SUBJECT: NuScale Power, LLC Response to NRC Request for Additional Information No. 103 (eRAI No. 8916) on the NuScale Design Certification Application

REFERENCE: U.S. Nuclear Regulatory Commission, "Request for Additional Information No. 103 (eRAI No. 8916)," dated July 25, 2017

NuScale Response to NRC Request for Additional Information eRAI No. 8916

eRAI No.: 8916

Figure 9.3.6-1: Containment Evacuation System Diagram

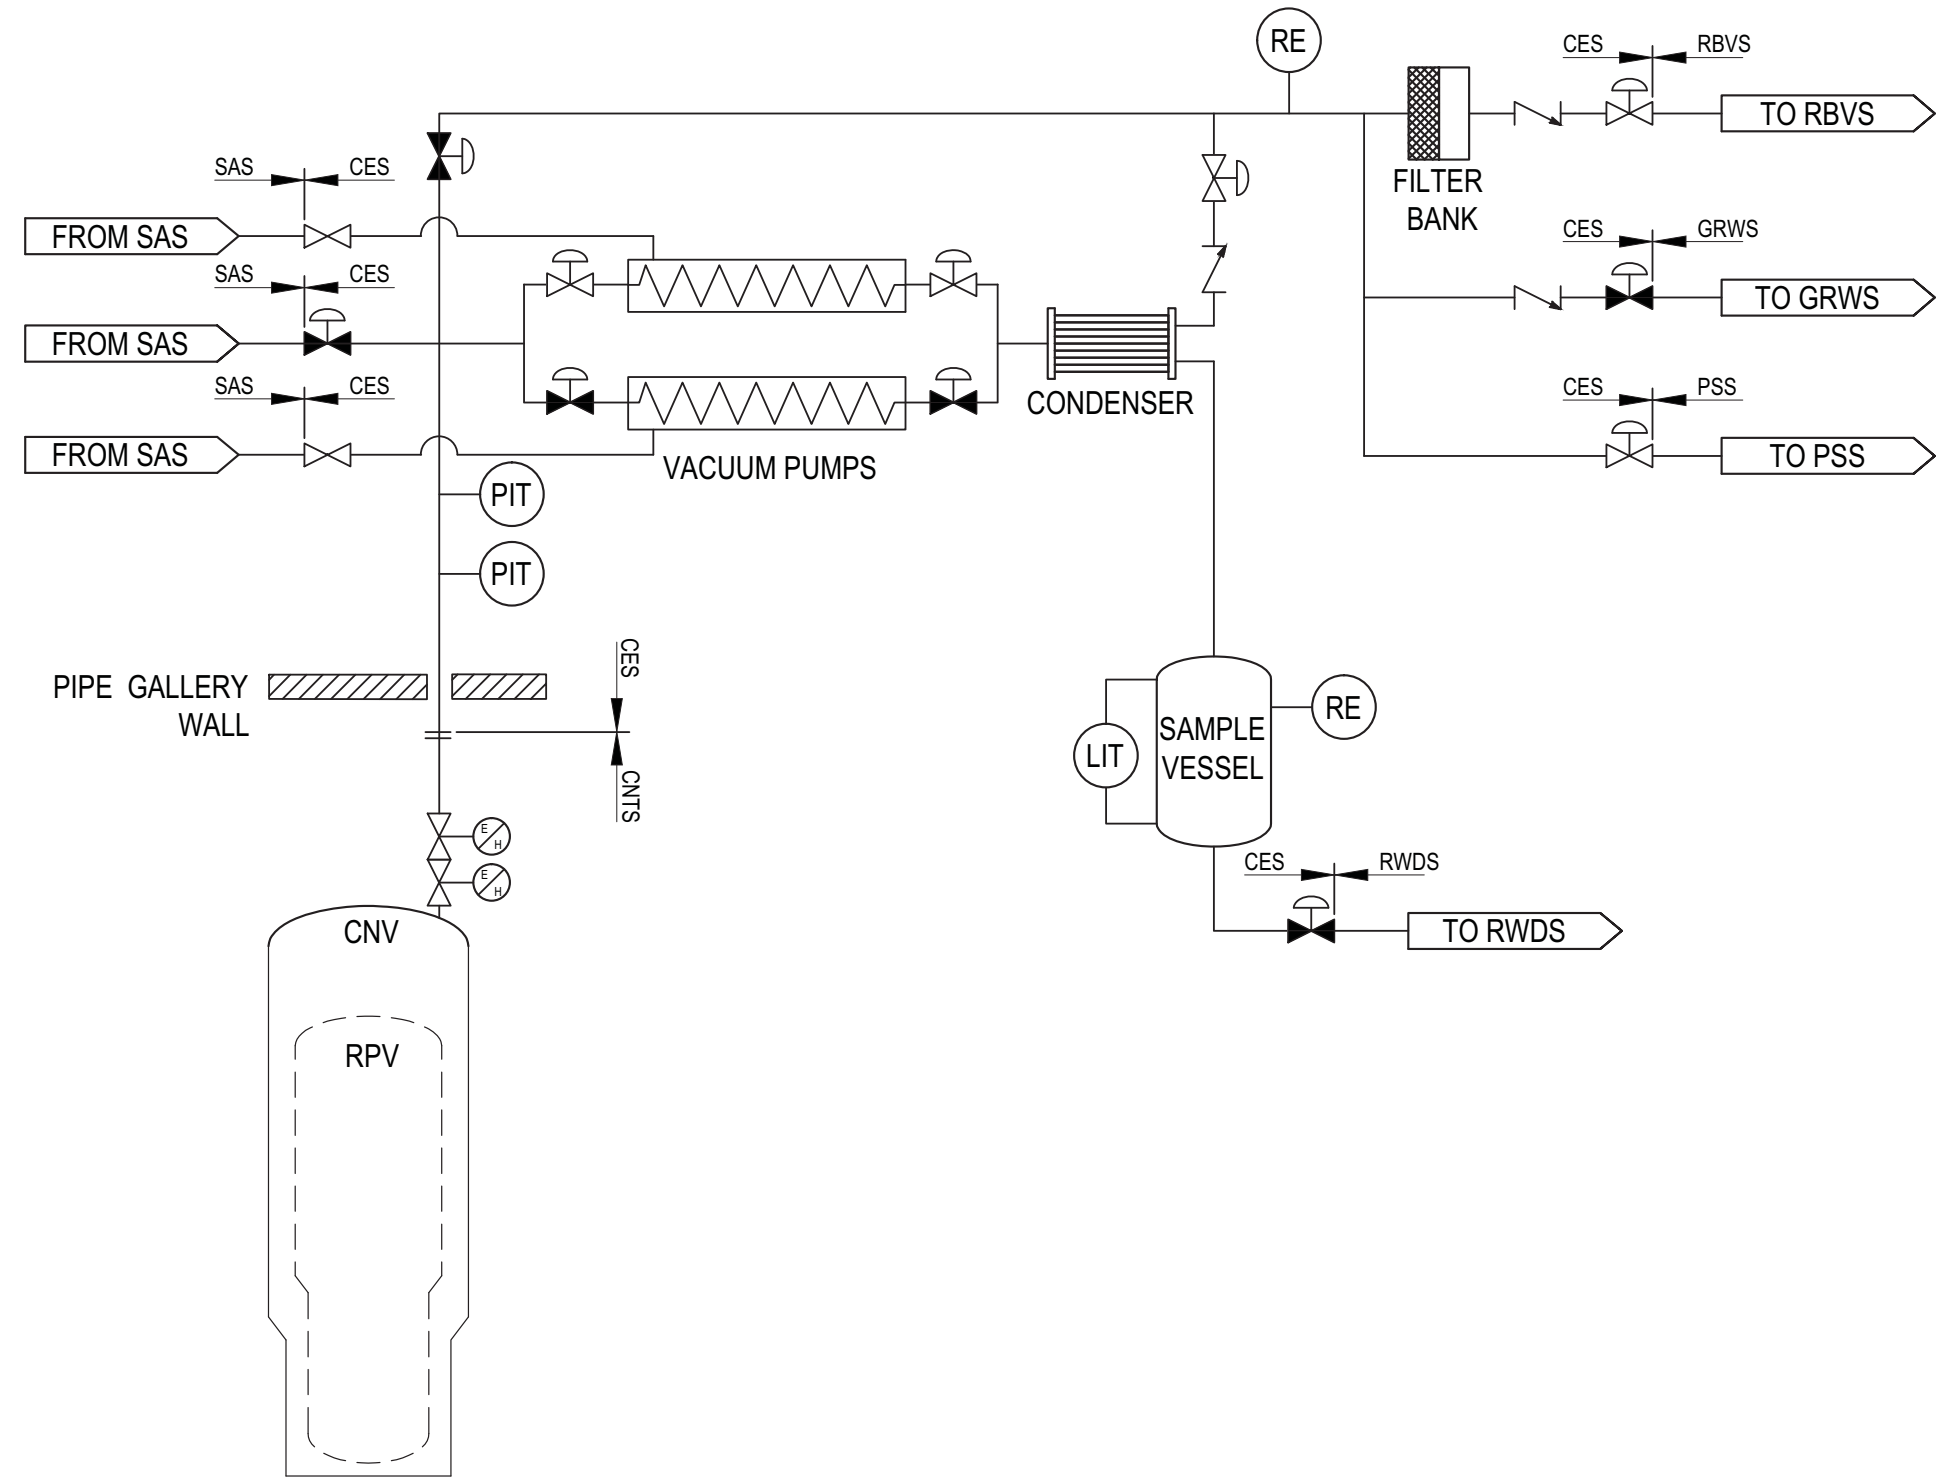
NuScale DCD, Tier 2, Figure 9.3.6-1, shows only a single line coming from the service air system to the CES. Therefore, isolating service air to the CES would automatically isolate the CES vacuum pumps; as such, the reason for identifying two separate isolating functions is not clear.

NuScale is requested to clarify and provide a markup to update the DCD accordingly.

There is only one isolation function of service air to the CES triggered by the high radiation signal or failure of the radiation monitor. The redundancy noted in the RAI has been removed from FSAR Section 9.3.2.6. In addition, Figure 9.3.6-1 has been revised to show that the CES design includes three supply air lines from the SAS.

FSAR Section 9.3.2.6 and FSAR Figure 9.3.6-1 have been revised as described in the response above and as shown in the markup provided in this response.
